**HORIZONTAL DIRECTIONAL DRILL ANALYSIS
YELLOW BREECHES CREEK CROSSING
PADEP SECTION 105 PERMIT NO.S: E21-449
PA-CU-0203.0000-WX & PA-CU-0203.0000-WX-16
(SPLP HDD No. S2-0250)**

This reanalysis of the horizontal directional drill (HDD) installation of a 16-inch and 20-inch diameter pipeline crossing under Yellow Breeches Creek, is in accordance with Stipulated Order issued under Environmental Hearing Board Docket No. 2017-009-L for HDDs listed on Exhibit 2 of the Stipulated Order. This HDD is number 14 on the list of HDDs included on Exhibit 2. This HDD was not initiated before the issuance of the Order.

ATTACHMENT 2

ORIGINAL AND REVISED HORIZONTAL DIRECTIONAL DRILL PLAN AND PROFILES

SCALE: 1"=200' DWG. NUMBER: PA-CU-0203.0000-WX

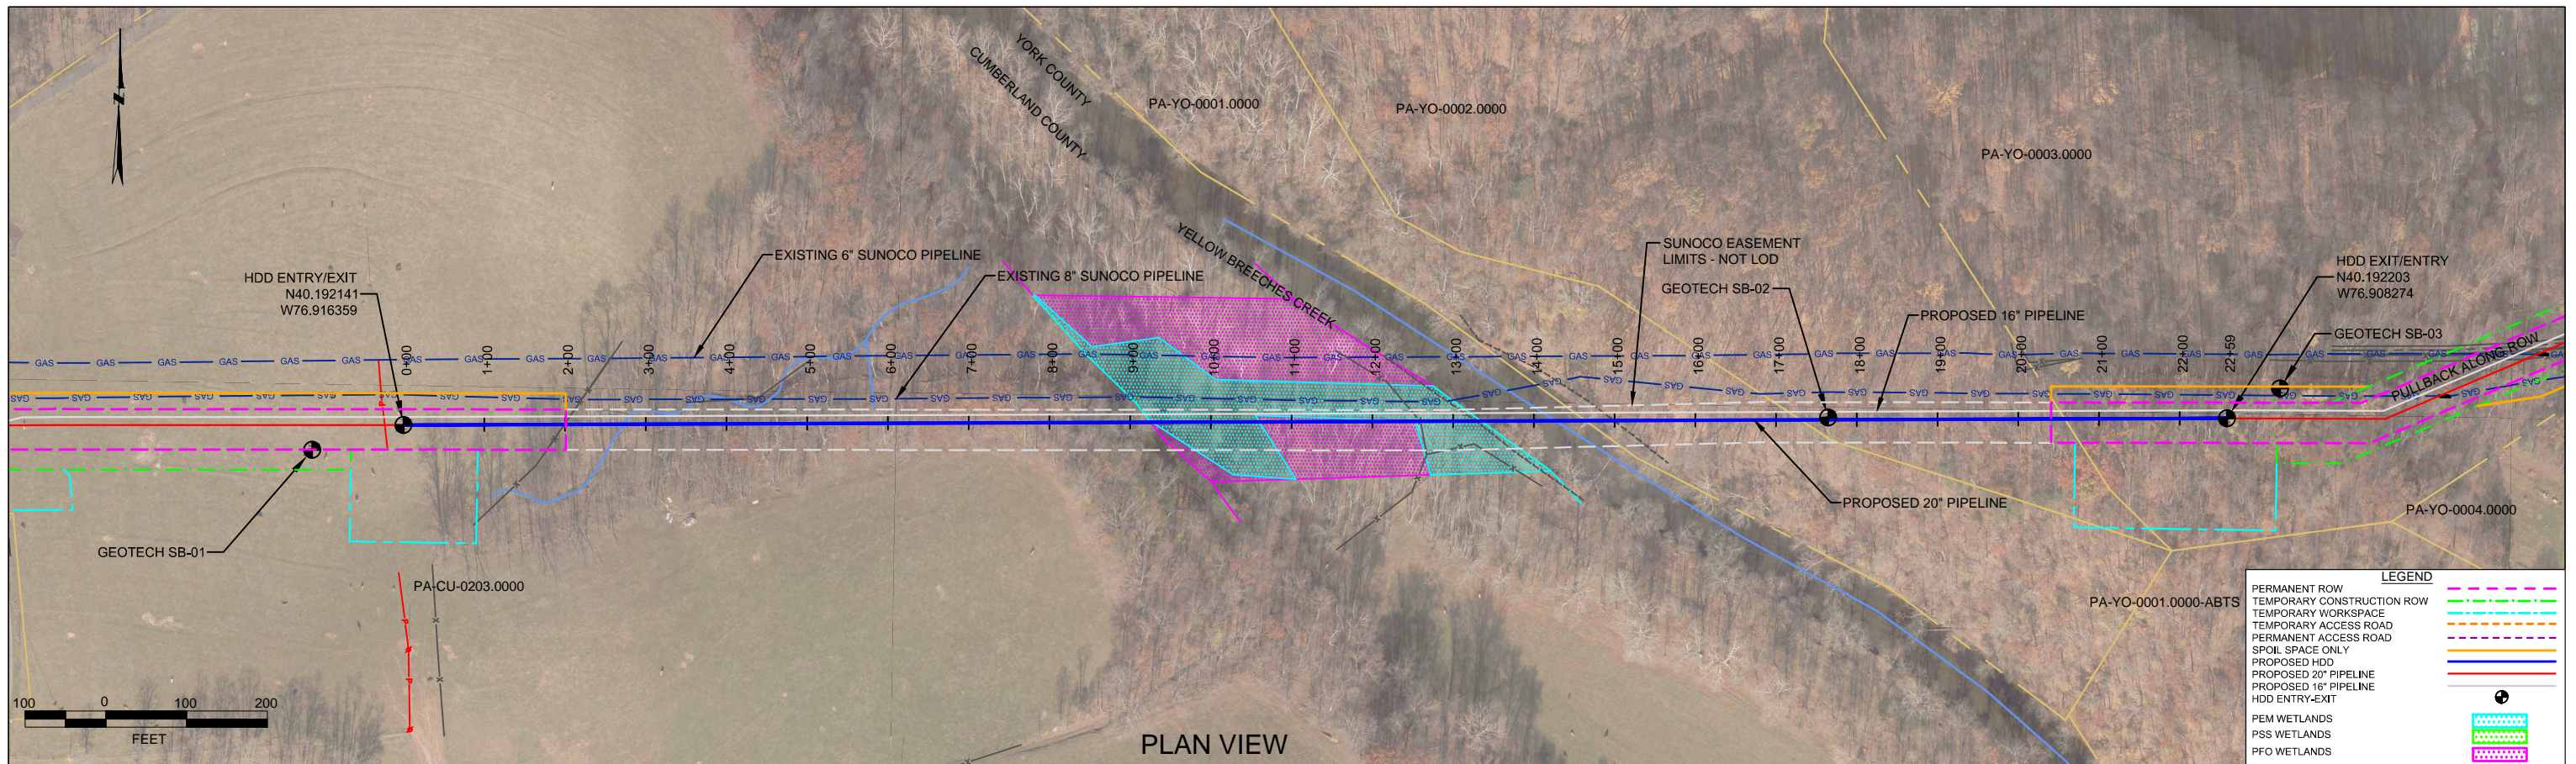
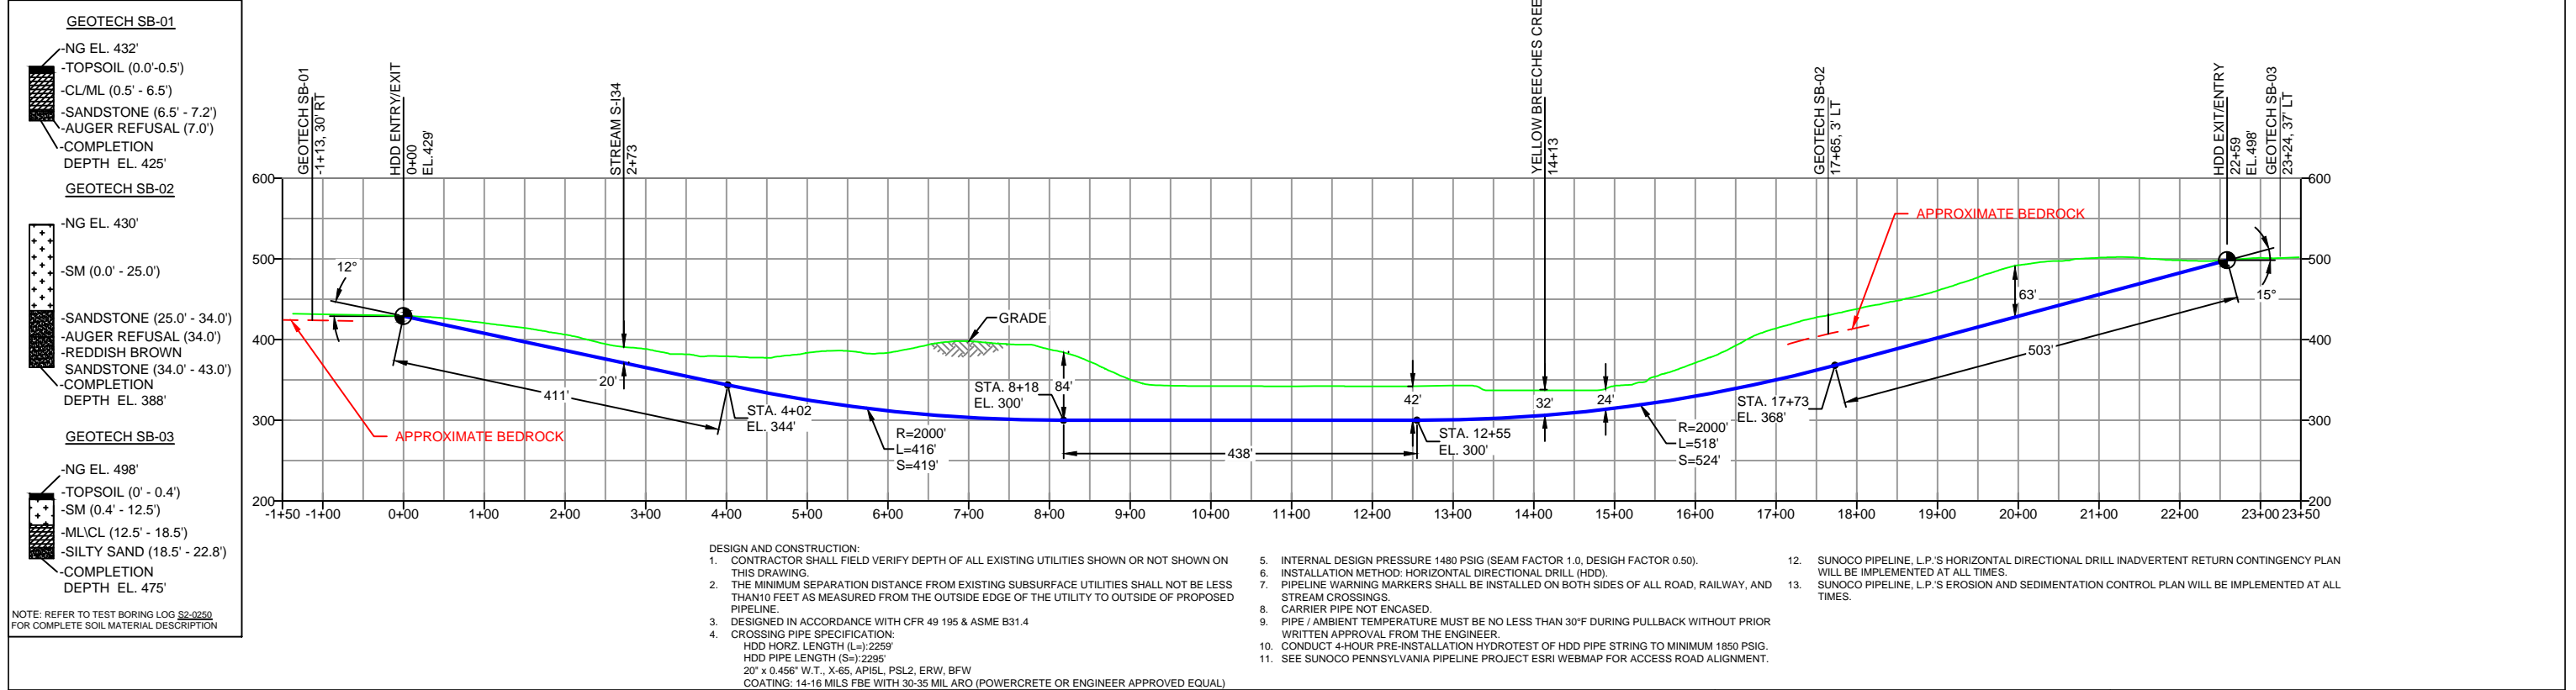
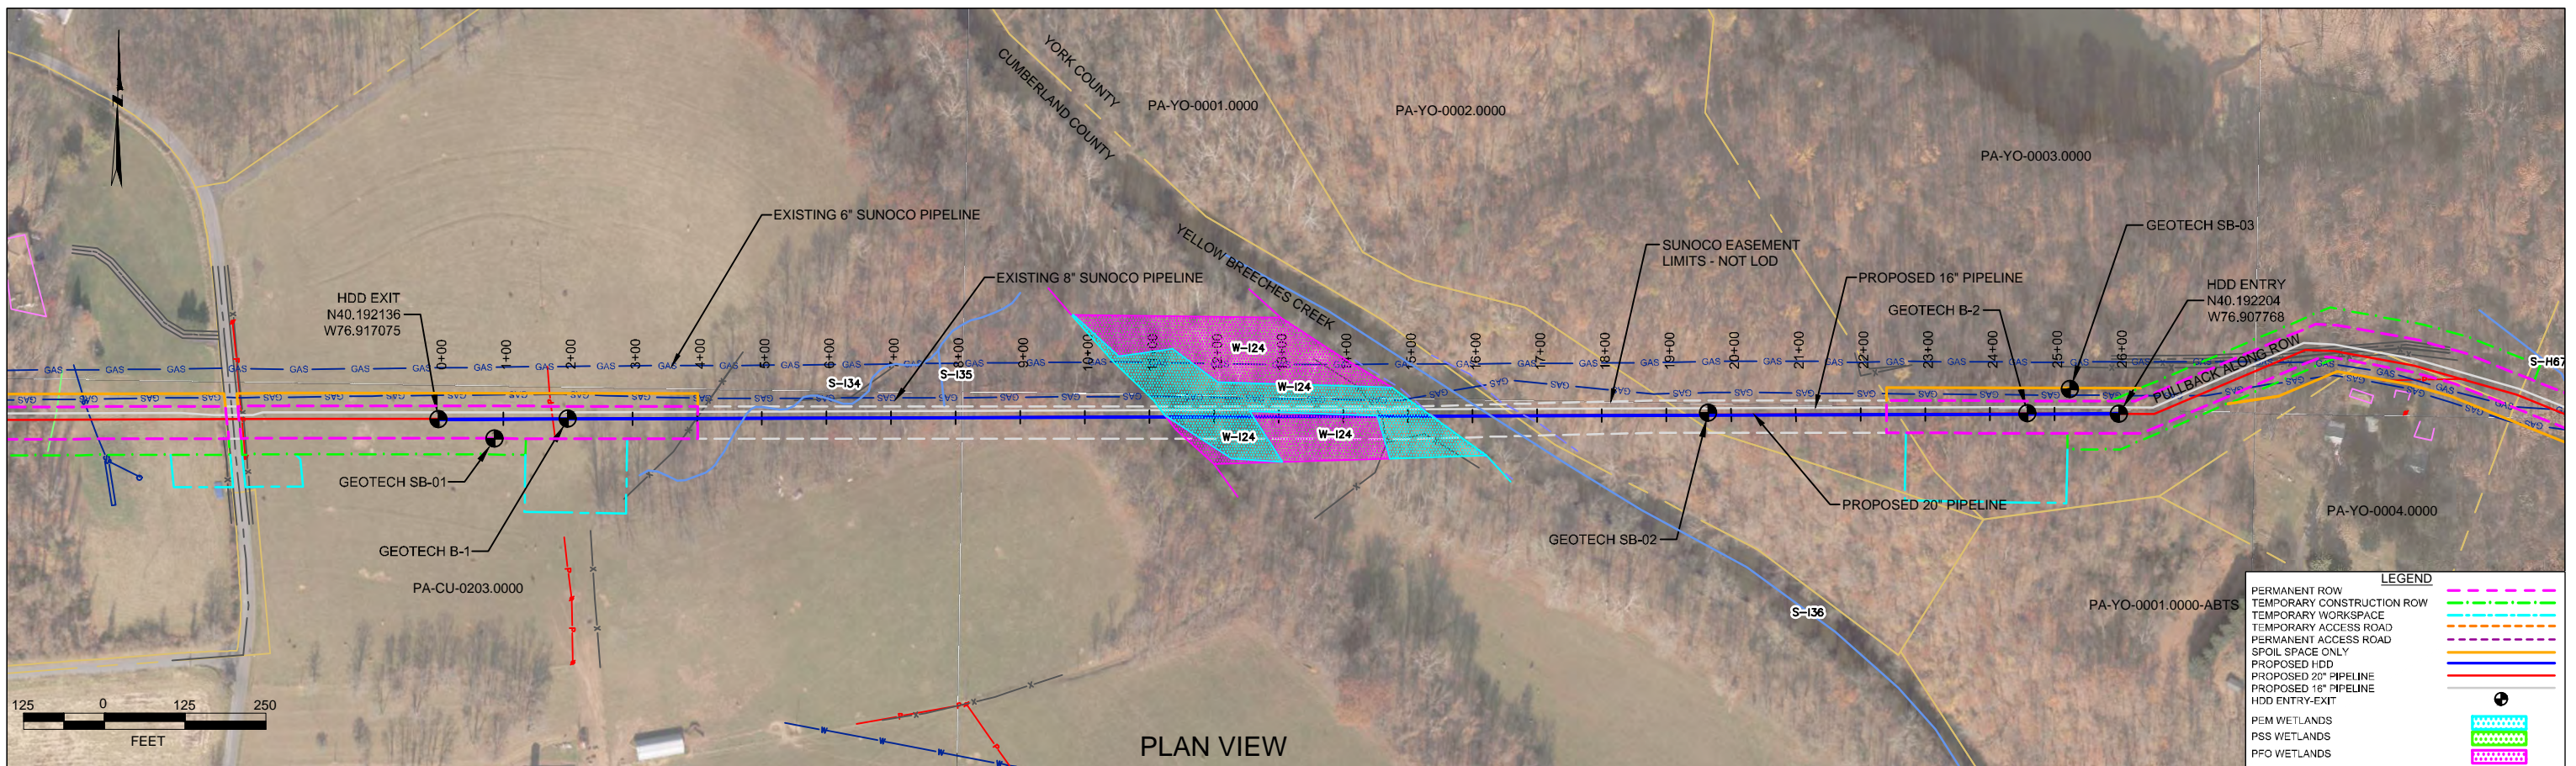
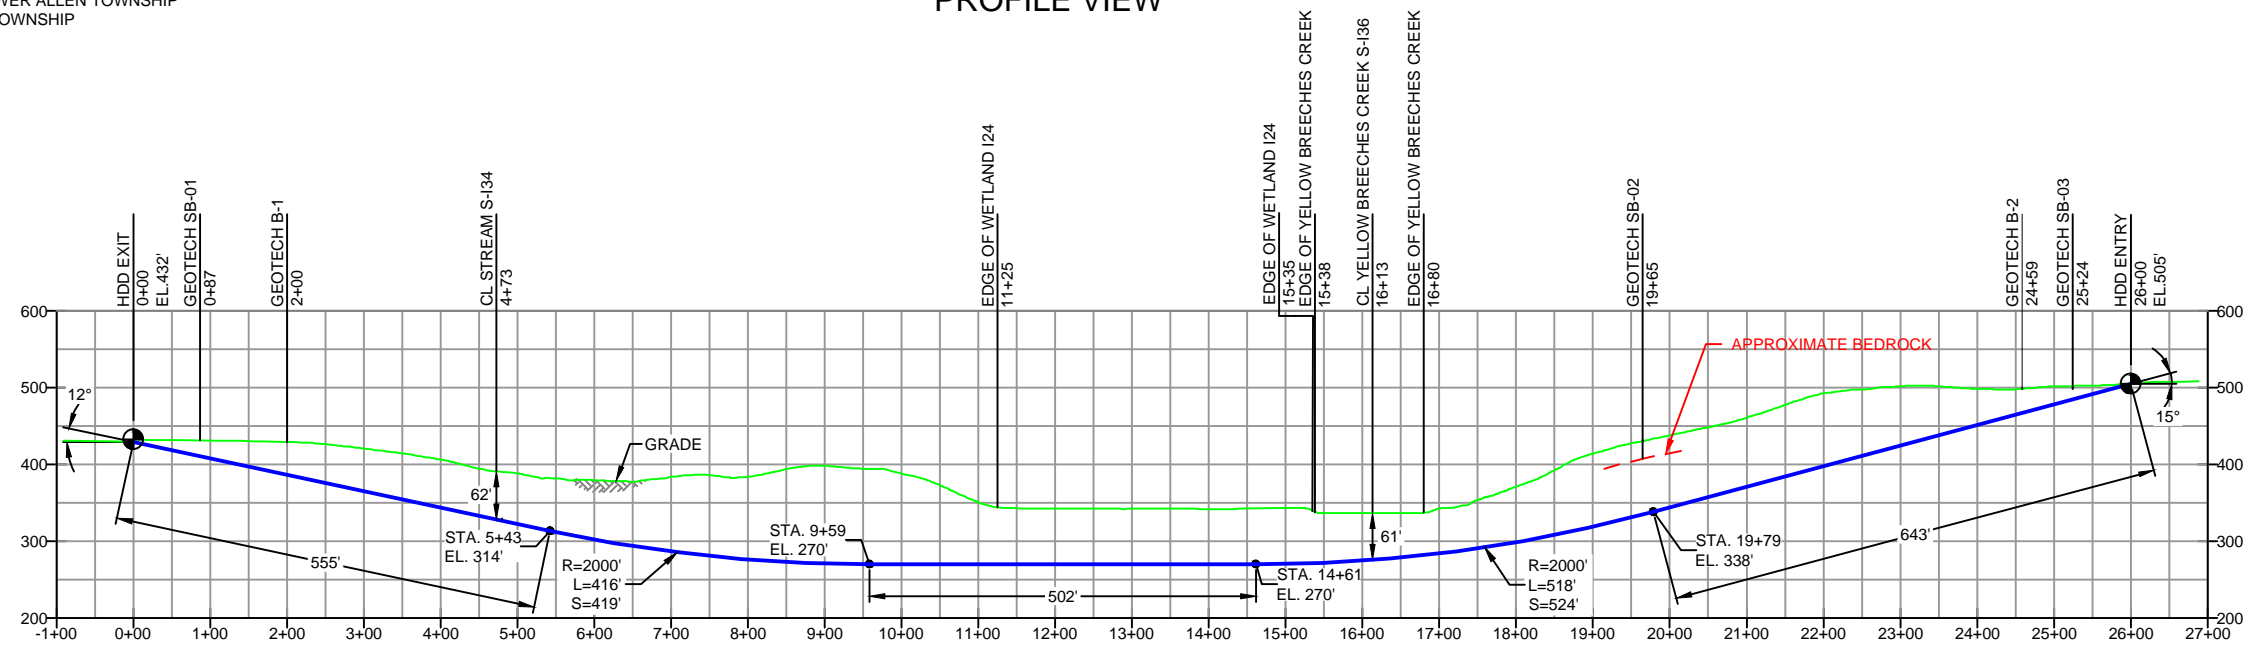
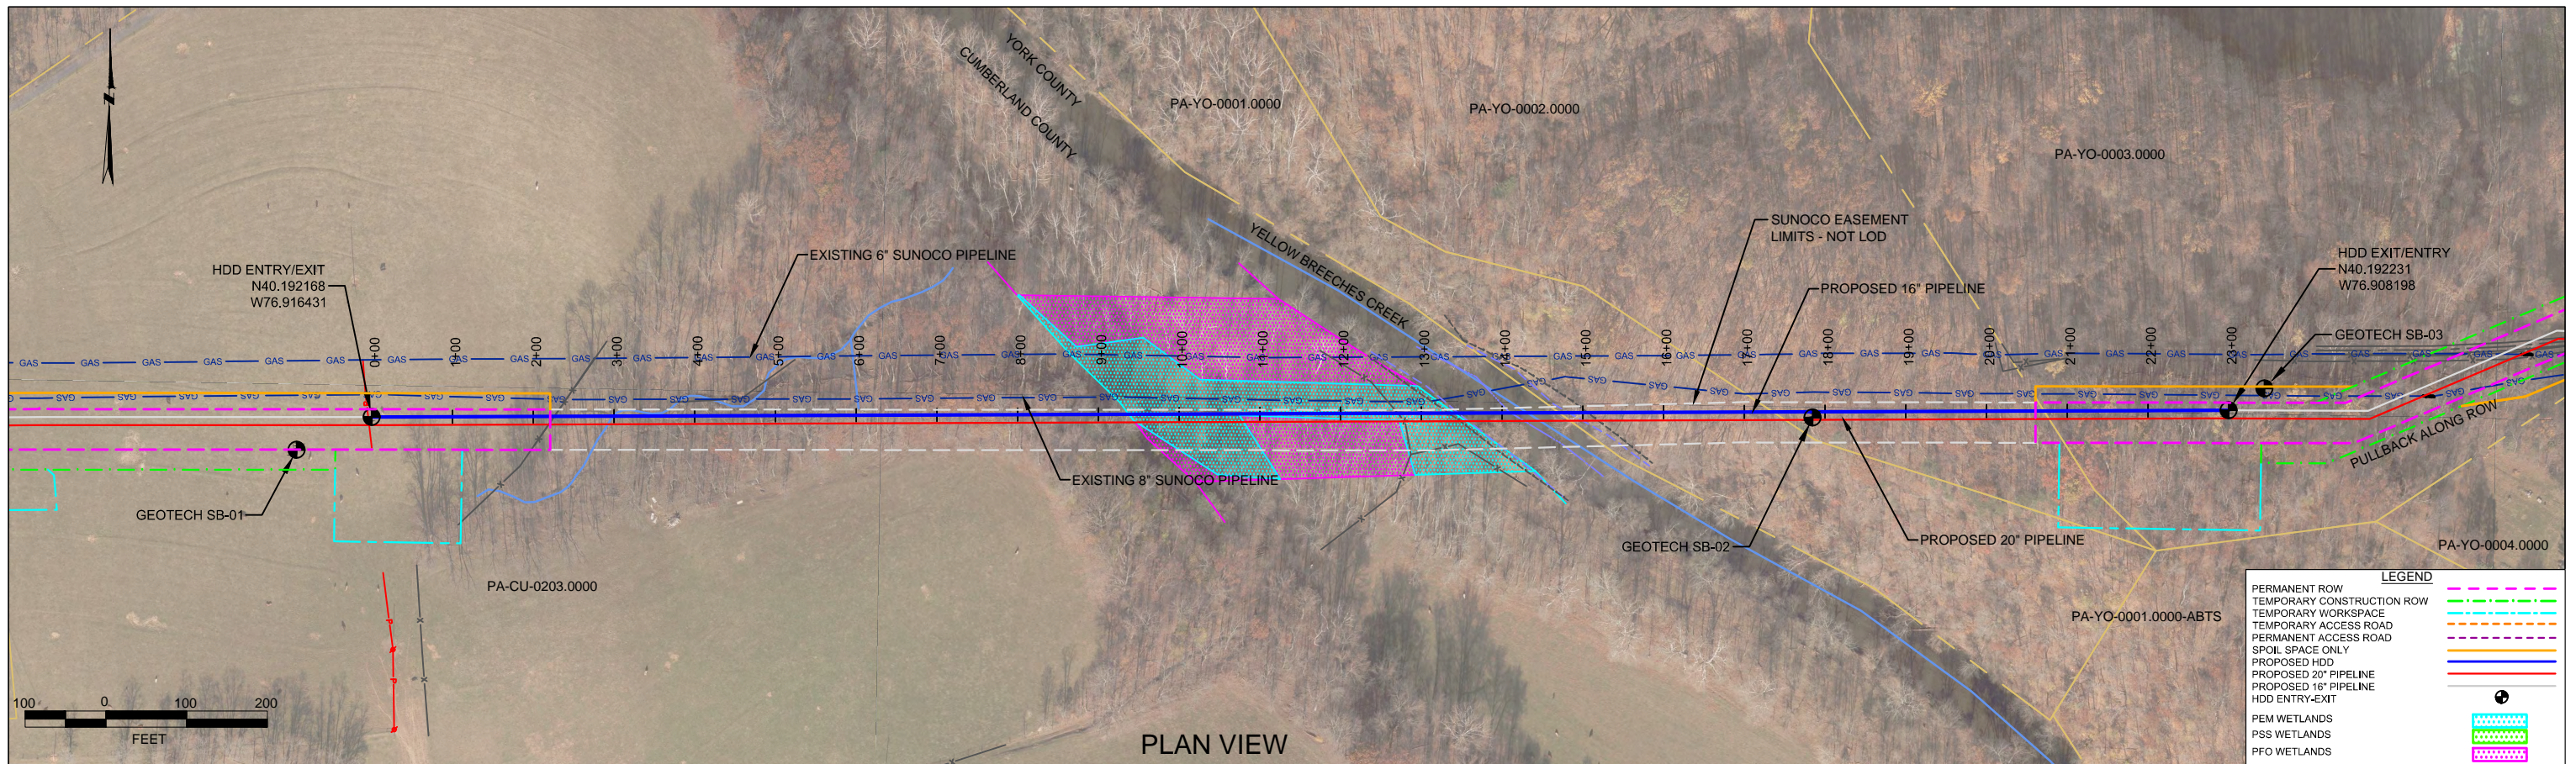
SPLP HDD consultants reviewed the HDD designs and geotechnical data for this area. Based upon this review, it was determined that the risk of IRs to waters overlying the HDD could be reduced by increasing the depth of the original permitted HDD profile. Additional geologic investigations have been completed and utilized in the redesign of the planned HDD. The redesign adjusts the HDD profile deeper to place the HDD pathway through bedrock having better structural integrity than a shallower profile and increase the overall length of the HDD due to pipe design requirements. A summary of the redesign factors is provided below.

REVISED HORIZONTAL DIRECTIONAL DRILL DESIGN SUMMARY: 20-INCH

- Horizontal length: 2,600 foot (ft)
- Entry/Exit angle: 12-15 degrees
- Maximum Depth of cover: 114 ft
- Depth under Yellow Breeches Creek: 61 ft
- Depth under wetland W-124: 71 ft
- Depth below Stream S-134: 62 ft
- Pipe design radius: 1,600 ft

It is SPLP’s intent to modify the original profile design and to pursue a deeper and longer HDD profile. Figures 1 and 3 in Attachment 2 presents the original HDD plan and profiles. Figures 2 and 4 presents the revised HDD plan and profiles.
